**MINUTES  
PLANNING COMMISSION  
116 WEST NEEDLES  
BIXBY, OKLAHOMA  
January 19, 2010          6:00 PM**

**To:** Bixby Planning Commission  
**From:** Erik Enyart, AICP, City Planner  
**Date:** Friday, January 15, 2010  
**RE:** Report and Recommendations for:  
AC-09-11-03 – Hardscape Materials, Inc. – Olsen-Coffey Architects

**To:** Bixby Planning Commission  
**From:** Erik Enyart, AICP, City Planner  
**Date:** Thursday, January 14, 2010  
**RE:** Report and Recommendations for:  
AC-10-01-05 – Taco Bueno # 3081 – Burson & Williams Architects, Inc.

**01 SITE PLAN**  
SCALE: 1/8" = 1'-0"

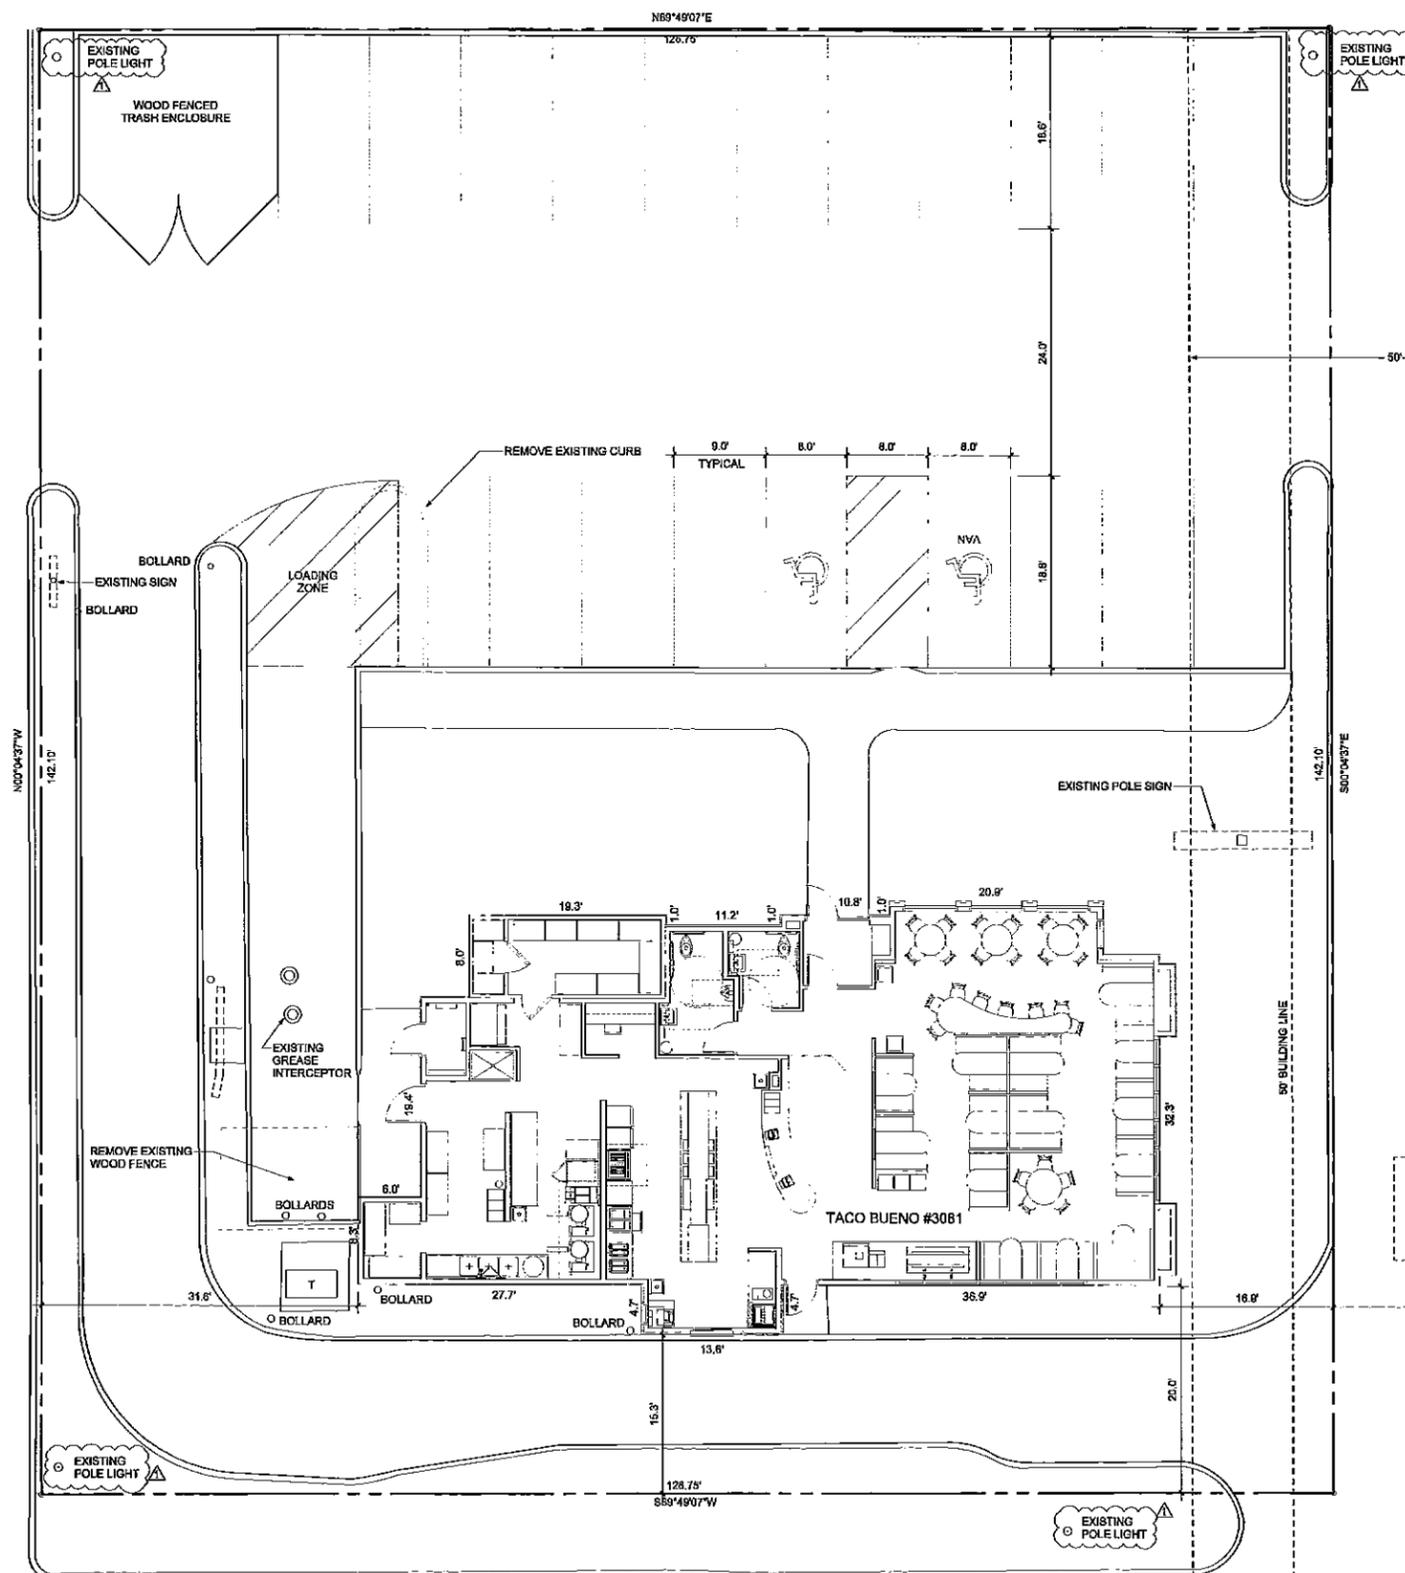
General. The Site Plan Drawing A0.0 indicates the location of the existing site as developed. The Site Plan represents a relatively conventional, suburban-style fast food restaurant with a drive-through lane. There is a parking lot on the north side of the lot with 11 parking spaces on the north, and eight (8) or nine (9) parking spaces on the south of an east-west internal drive.

Based on the location of the 50' building line indicated on the Site Plan Drawing A0.0, it appears that the existing building footprint, for the most part, complies with the 50' setback requirement from Memorial Dr. per Zoning Code Section 11-7D-4 Table 2. However, per the Tulsa County Assessor's parcel and aerial data, it appears that a relatively recent (presumably the circa 2005 Memorial Dr. widening project) ODOT right-of-way parcel acquisition, "Part of Lot 1 Beginning 39.92' North of the Southeast Corner of Lot 1 Thence North 24' Thence West 20.55' Thence South 24' Thence East 20.53' to the Point of Beginning, Block 1, Wal-Mart Stores Addition," has caused the building's setback to be legally nonconforming by approximately nine (9) feet.

The Site Plan Drawing A0.0 does not provide the building's dimensions or the distances to the front/east or nearest side yard line. This data must be provided on a revised site plan resubmittal.

There is another line parallel to the 50' building line which uses the same line type symbology, but it is not described. According to the recorded plat of Wal-Mart Stores Addition, it appears this may be a 50'-wide ONG easement recorded at Book 1430 Page 1042. This line needs to be designated on the Site Plan Drawing A0.0. The area needs to be adequately described and differentiated from the Building Line setback.

Per Zoning Code Section 11-7D-4 Table 2, the minimum frontage requirement in the CS district is 150'. Per the submitted Site Plan Drawing A0.0, the subject property measures only 142.10' from north to south, and so would not meet this frontage requirement, even if the lot abutted Memorial Dr., instead of another lot.

The Site Plan Drawing A0.0 does not indicate the width of the drive aisle, consisting of the east-west drive along the north side of the lot. The drawing also does not indicate the width of the north-south drive separating the subject property from Memorial Dr. This information is needed to allow for adequate review.

Parking Standards. The Site Plan Drawing A0.0 indicates there are 19 or 20 parking spaces (2 of which are handicapped-accessible) in existence. Per Zoning Code Section 11-9-15.D, for 2,653 square feet of building on the lot, 17.68 (18) parking spaces would be required. The 19 or 20 spaces comply with the minimum number of parking spaces required.

Per the Building Inspector, the ADA guidelines require one (1) van-accessible design for the handicapped-accessible space, for up to seven (7) accessible spaces. The Site Plan Drawing A0.0 does not indicate if either of the two (2) spaces is van-accessible.

Zoning Code Section 11-10-4.A requires a 9' X 20' minimum dimension standard design. The Site Plan Drawing A0.0 does not indicate the dimensions of the existing parking spaces.

*Outdoor Lighting. The Site Plan Drawing A0.0 indicates the location of the existing light poles, located at or about the four (4) corners of the lot. These would appear appropriate for this development in its context, and a photometric plan should not be required for something as simple as a building restoration on an existing developed site.*

*Signage. The Site Plan Drawing A0.0 represents the location of one (1) existing ground sign, located toward the center of the east side of the lot. Per the Site Plan, there is another ground sign located toward the back/west side of the lot. None of the site plan drawings, including the signage plan by Starlight Sign LP drawing #0912-079, indicate the height, dimensions, or other such details for these existing signs.*

EAST ELEVATION  
SCALE: 1/4" = 1'-0"

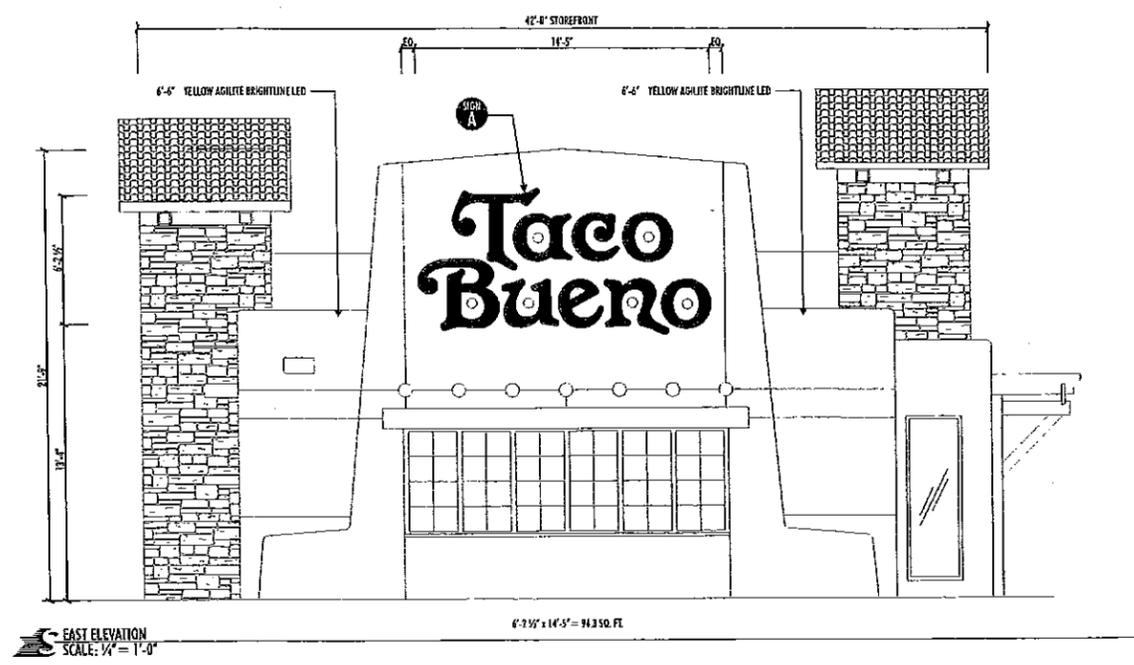
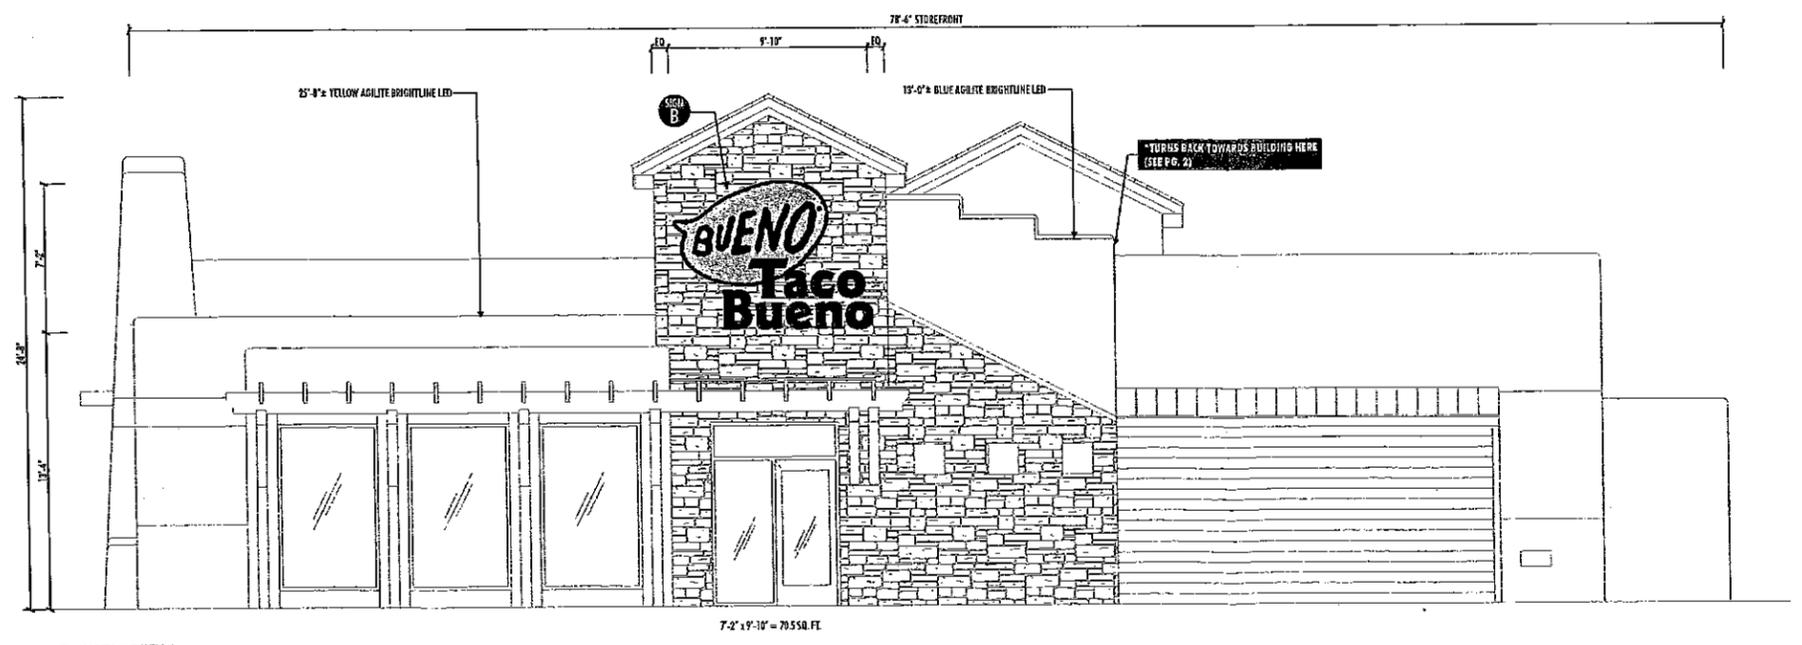
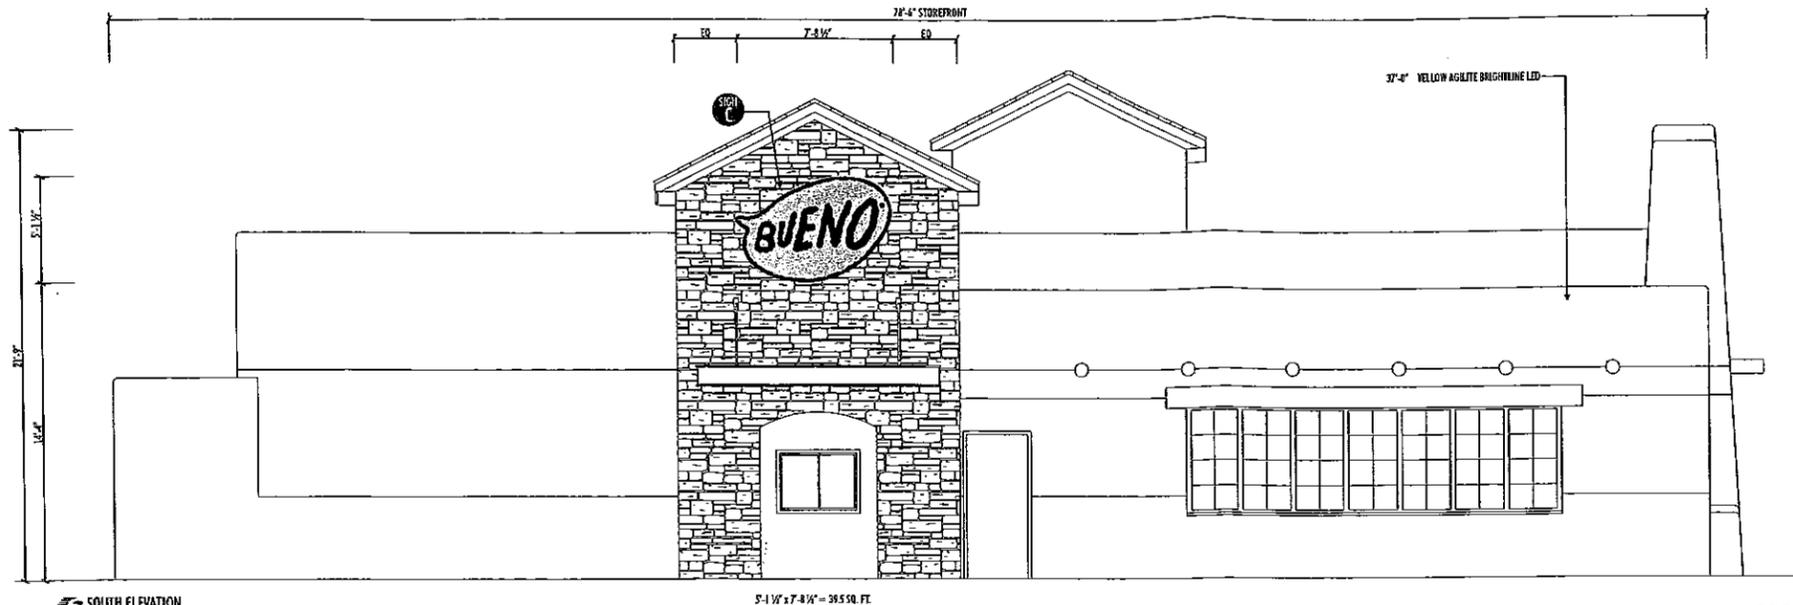
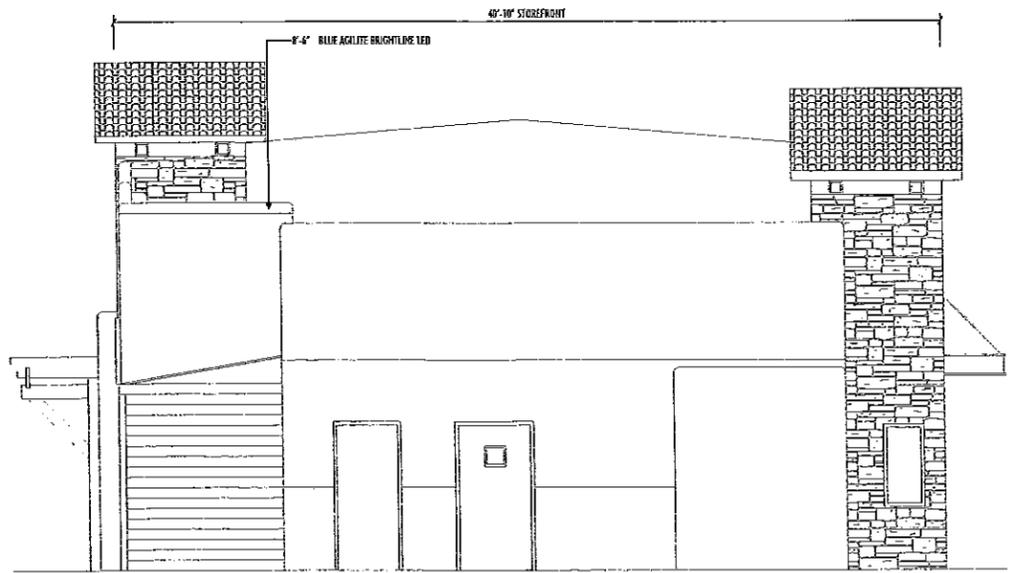
*The exterior materials will be primarily (1) existing and replacement [yellow and gray] stucco with (2) “SSV-1” (which appears to be stone masonry) architectural columns on the north and south sides, extended above the roof line as compared the current building height. The “SSV-1” should be specified on the plans as to its meaning.*

*The profile view/elevations drawings A4.0 and A4.1, together with the signage plan by Starlight Sign LP drawing #0912-079, indicate the sizes and relative locations of the wall signs.*

*In addition to the site plan drawings not providing this information, the profile view/elevations drawings do not dimension the wall widths, necessary for the comparison of the signage to the maximum display surface area allowable under the Zoning Code (See Section 11-9-21.D.2). They also need to be dimensioned.*
